APPROVED DRAWINGS HAVE BEEN RED LINED INDICATING A CHANGE TO MEET THE OBC. PLEASE REVIEW ALL PAGES TO ENSURE YOU ARE PROPERLY INFORMED OF CHANGES.

RSM Building Consultants
 These plans have been examined for compliance with the Ontario Building Code. This review has been completed subject to any changes noted, under the condition that the building will be constructed in accordance with the code.

Tice River Homes

Legacy

model: 40-02
scale: 3/16" = 1'0"
project #: 17052
page: **A1**

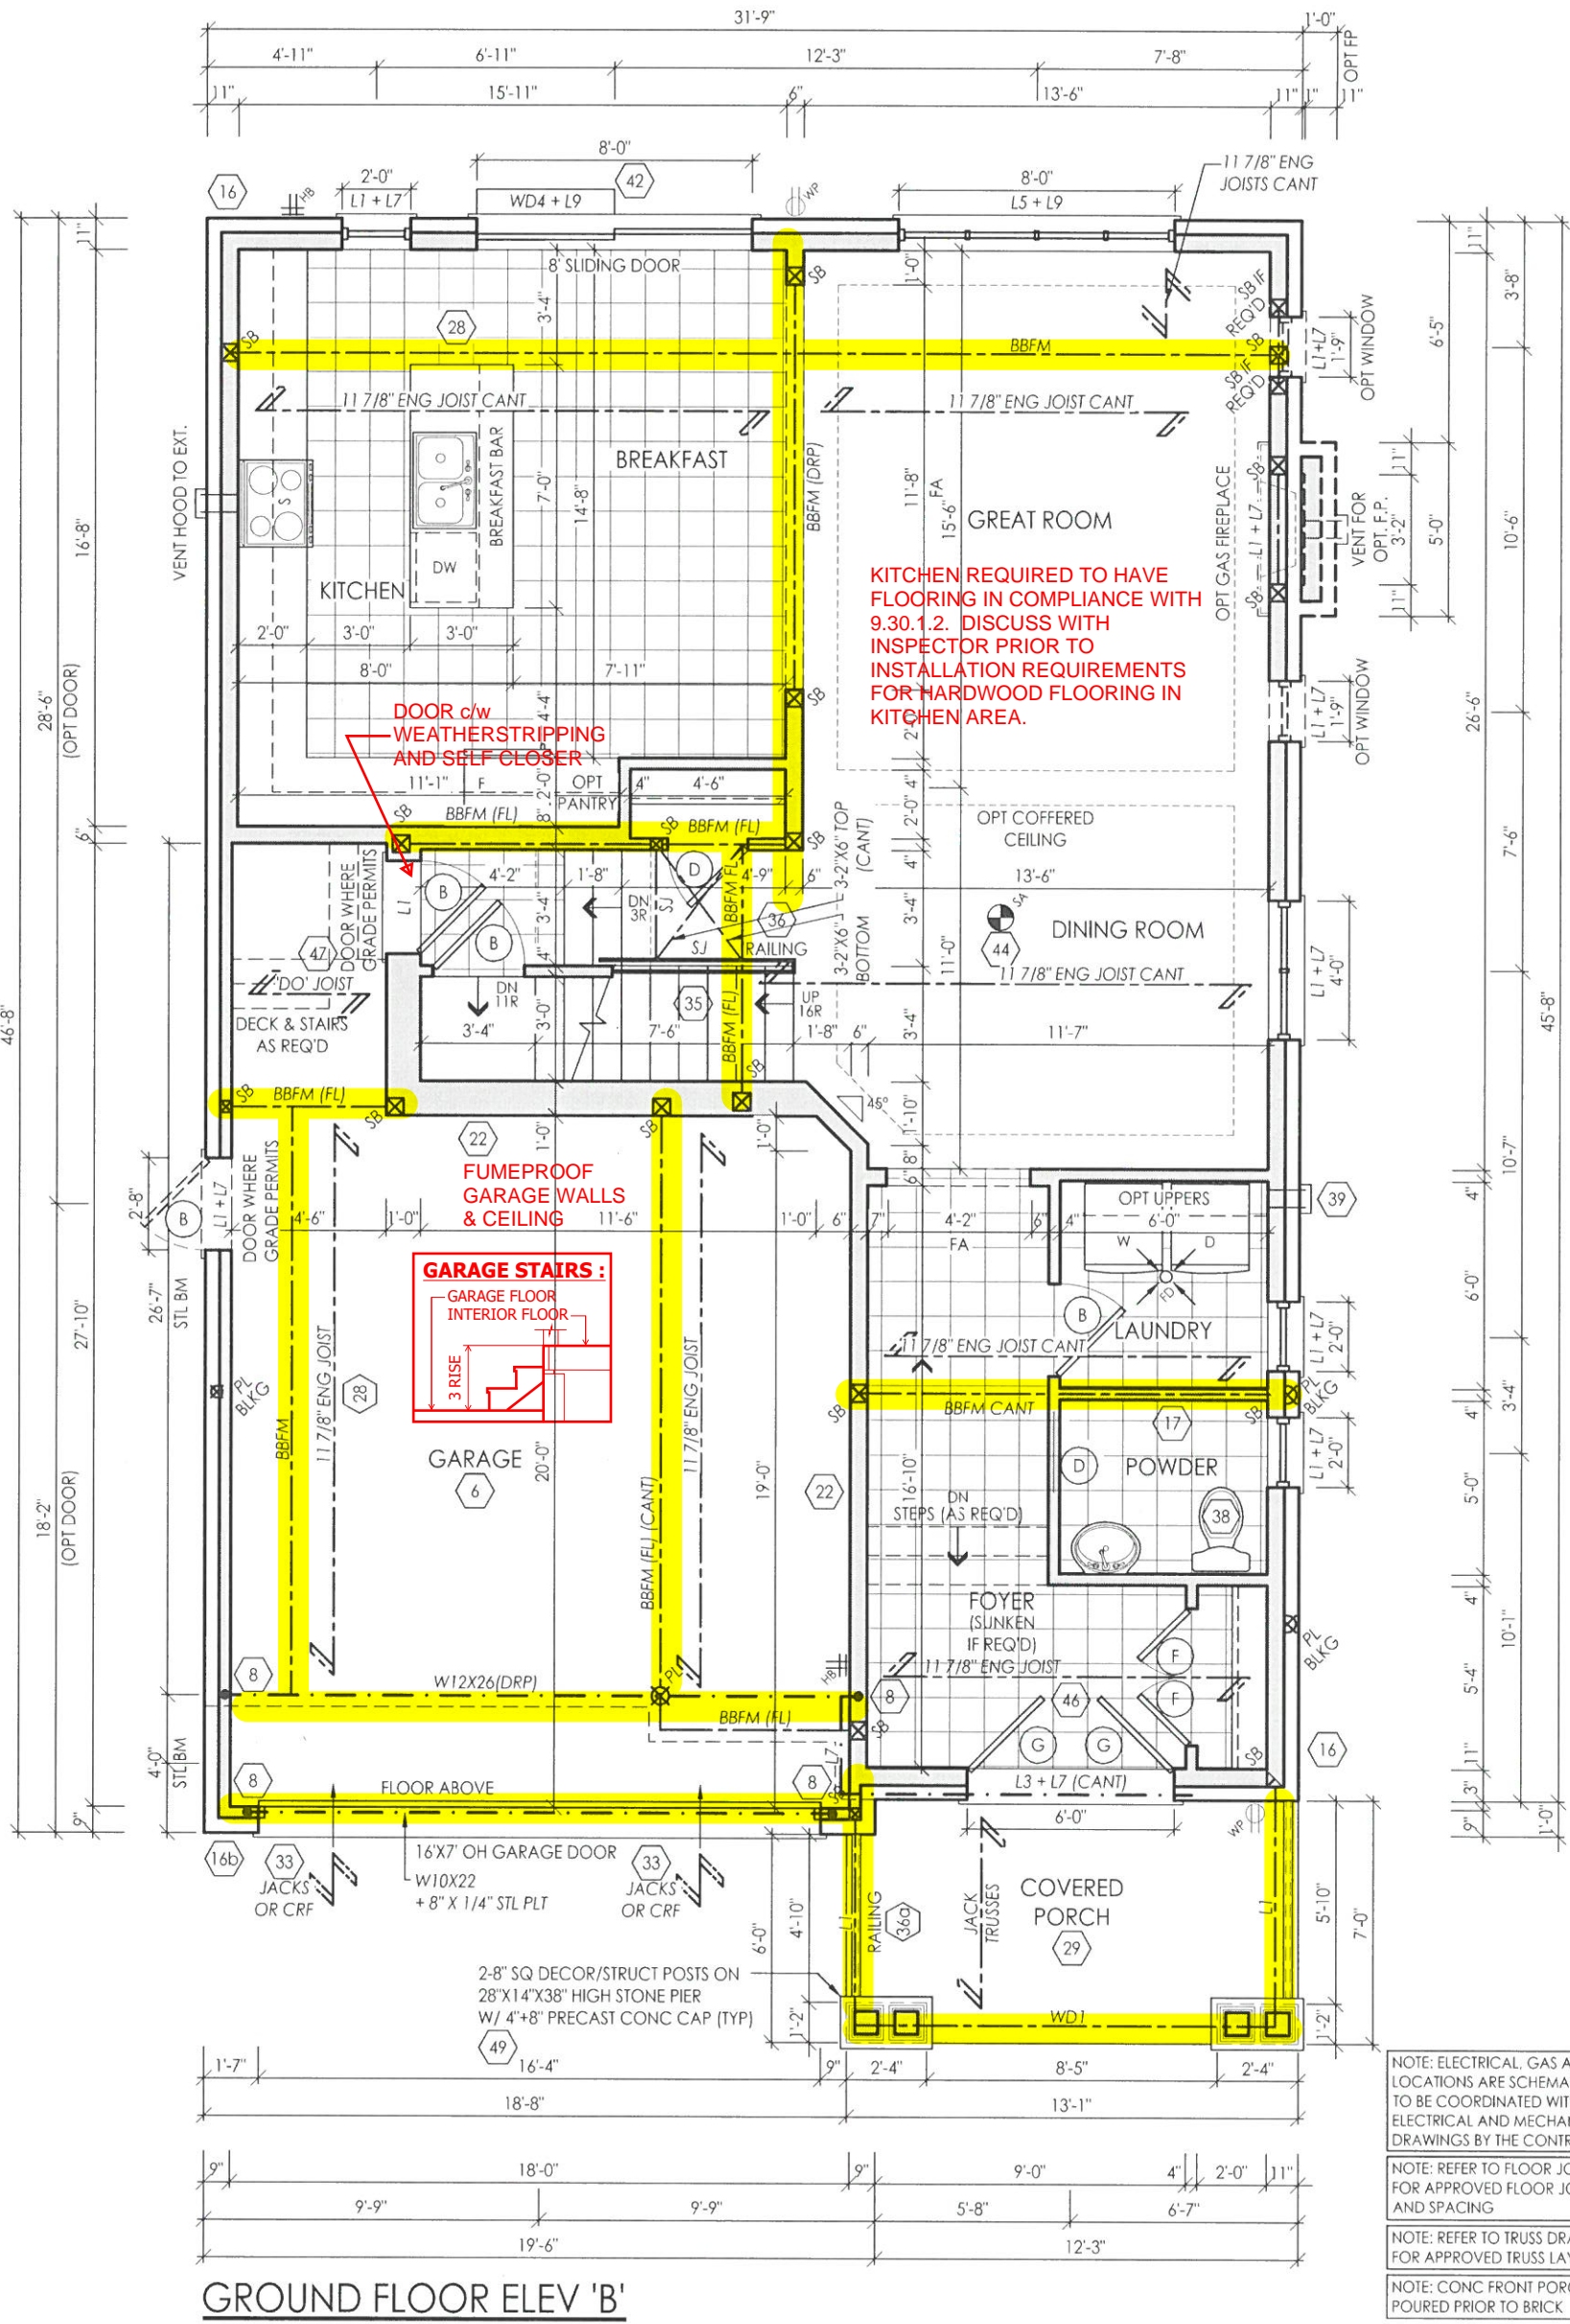
**BASEMENT AIR BARRIER
SUMP PUMP LIDS, JOINTS AT INTERSECTIONS & ALL
PENETRATIONS OF SLAB MUST BE SEALED TO
PREVENT AIR LEAKAGE.**

SECOND FLOOR ELEV 'B'

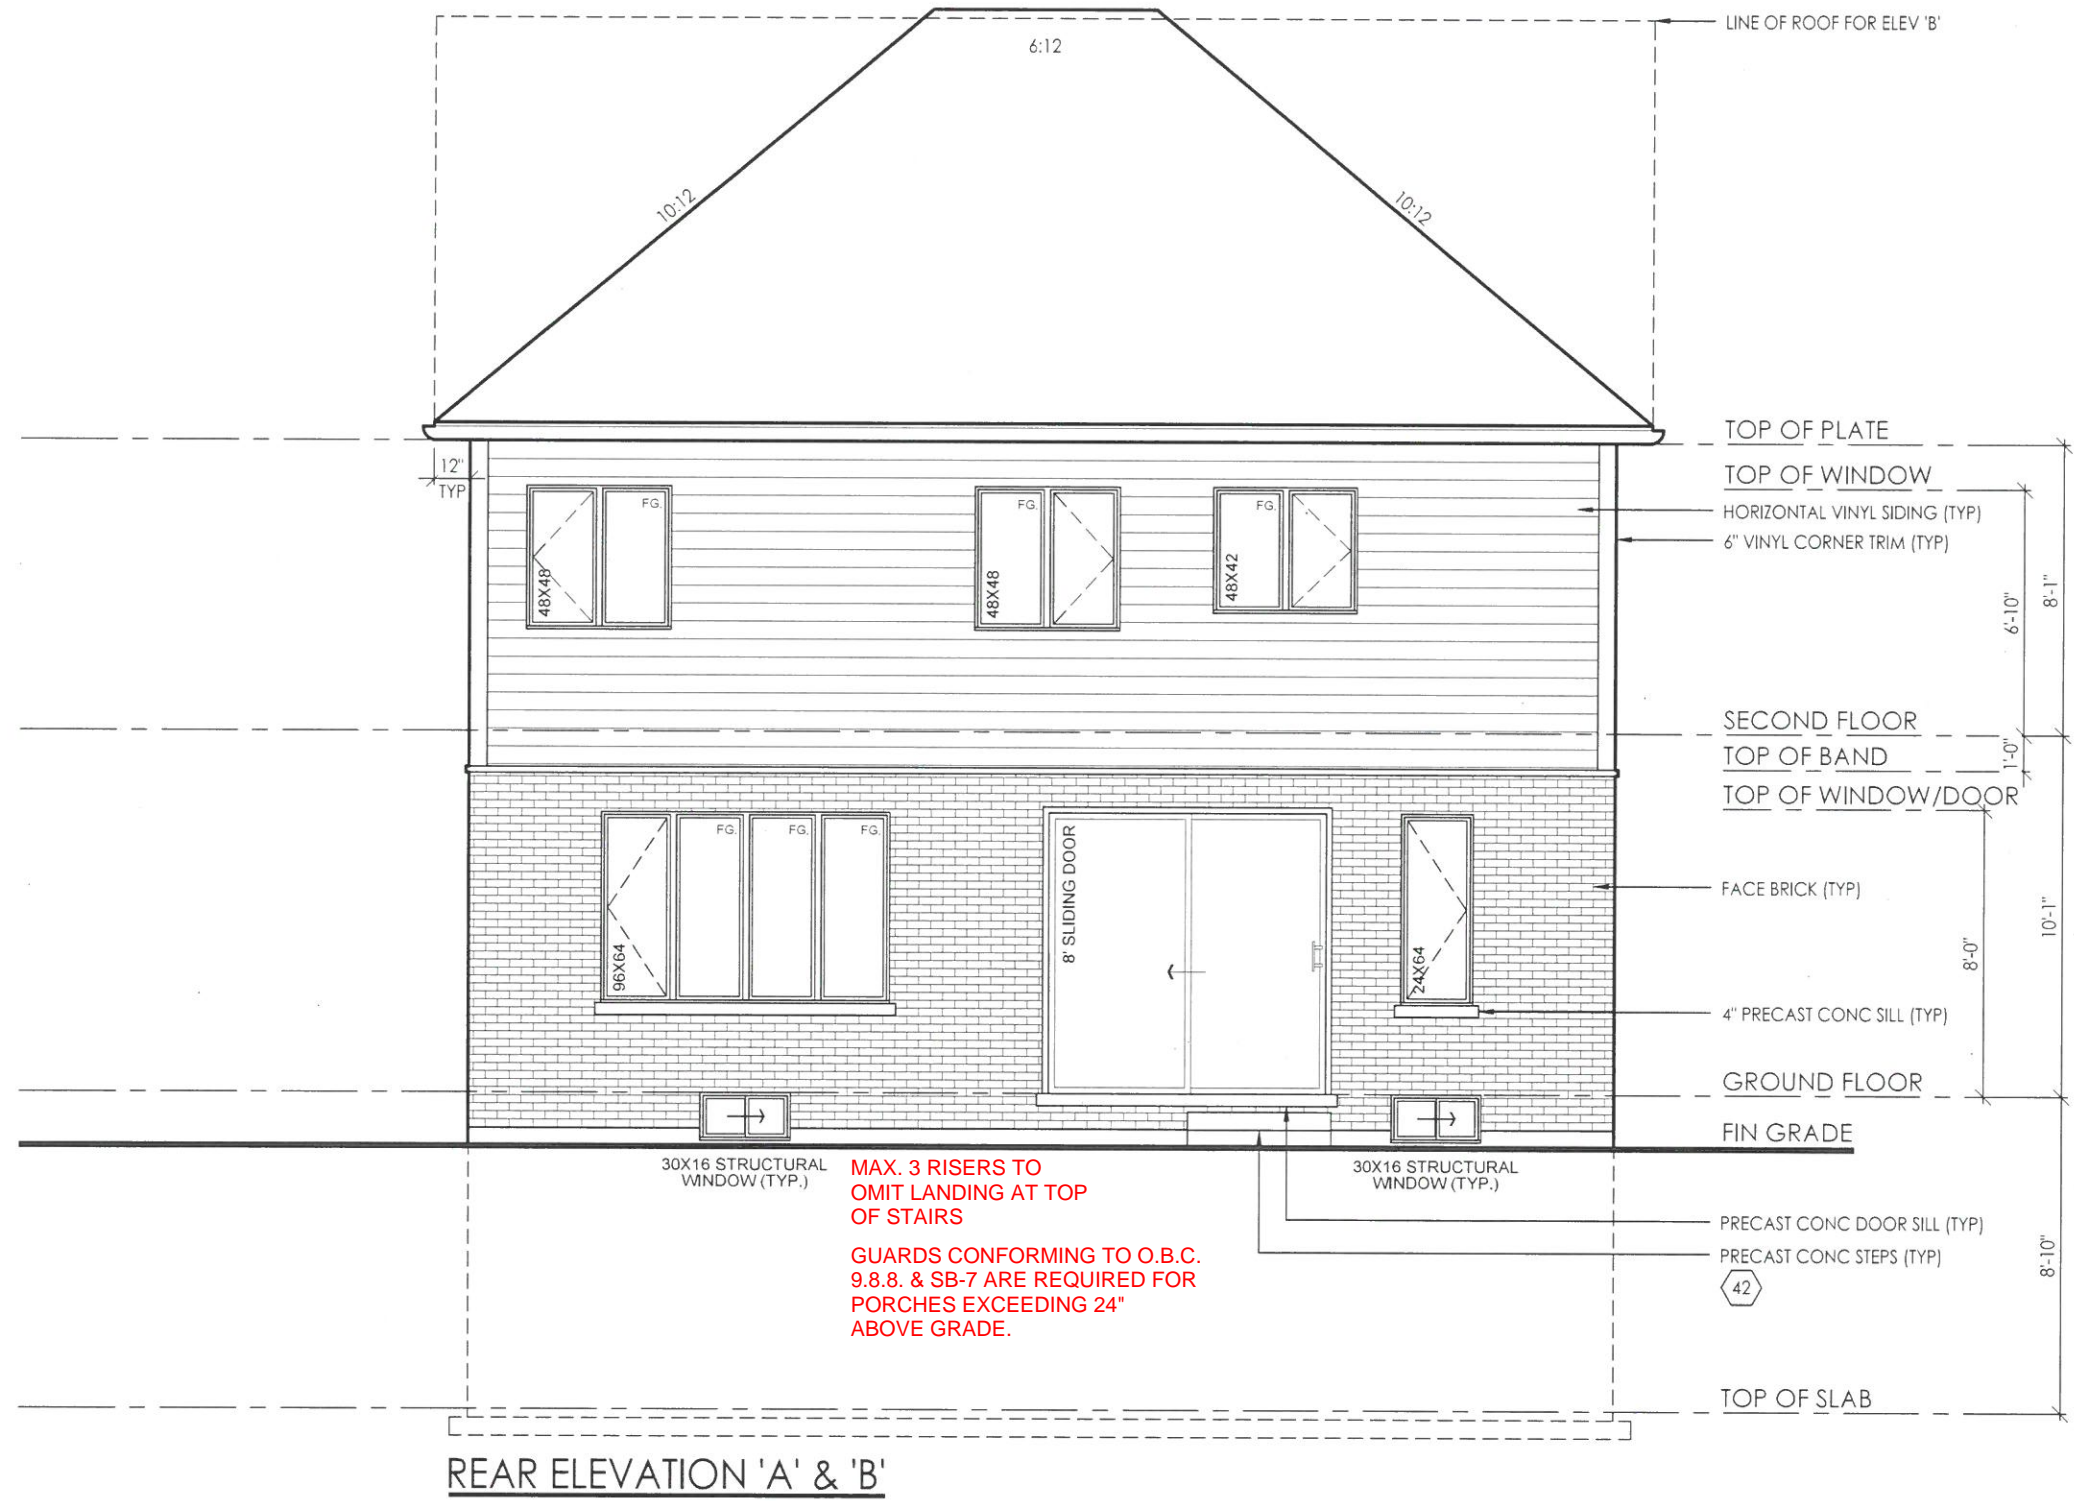
A SMOKE ALARM SHALL BE INSTALLED ON EACH FLOOR LEVEL AND WITHIN EACH SLEEPING ROOM. ALL SMOKE ALARMS SHALL BE INTERCONNECTED. EACH DEVICE SHALL HAVE A VISUAL SIGNALING COMPONENT IN ADDITION TO THE TEMPORAL PATTERN IN CONFORMANCE WITH 18.5.3. OF NFPA 72.

DETAILS SEALED BY A PROFESSIONAL ENGINEER ARE REQUIRED FOR THE LVL BEAMS ON FRAMING INSPECTION

PROVIDE P.ENG APPROVED TRUSS & FLOOR DRAWINGS AND SPECIFICATIONS TO BUILDING INSPECTOR AT FRAMING INSPECTION.

A CARBON MONOXIDE DETECTOR SHALL BE LOCATED ADJACENT TO SLEEPING AREAS
